Technical Bulletin 54

**MDS-2310 Wiring to Reduce
Current Consumption**

Version 1.0, Revision AA (8 January, 2001)

1. Modified Wiring to Support Complete Duty Cycling MDS-2310 with 4800 Baud Modem:

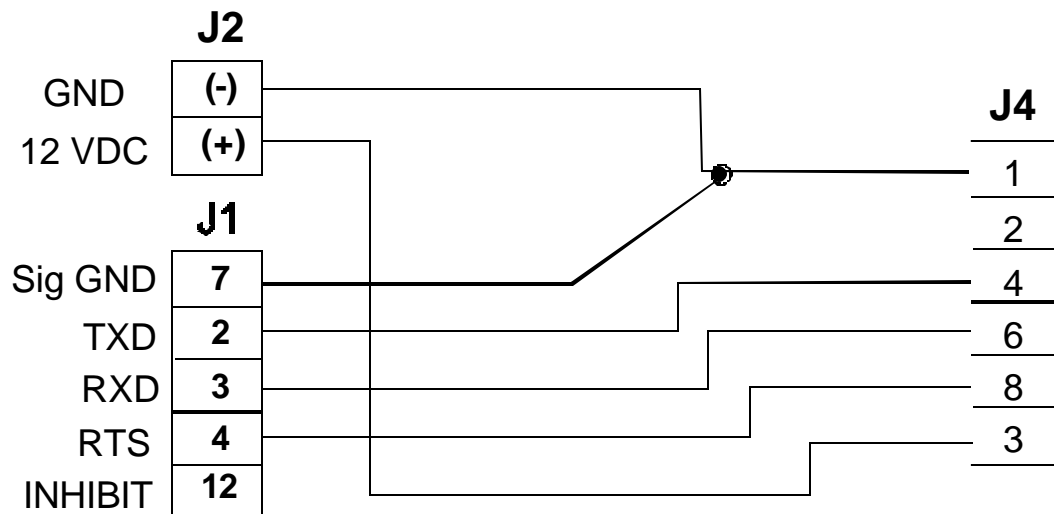
Modifications required to completely duty cycle MDS-2310 with FCU battery power. Can only be wired this way if MDS 2310 has internal 4800 baud modem with part # 031831 AO2 or 031831A11.

Advantage: Will reduce radio current consumption by 10-15 milli-amps. Part number is located on the modem board along with the Revision level.

- 1) Remove the 1.5 K ohm resistor
- 2) Remove the wire which is connected from Inhibit (Pin 12) of the radio to Switched 12 Volts of FCU
- 3) Remove the existing wire from +12 Volt of the radio to Vbatt of FCU
- 4) Connect +12 Volts of the radio to Switched 12 Volt of the FCU
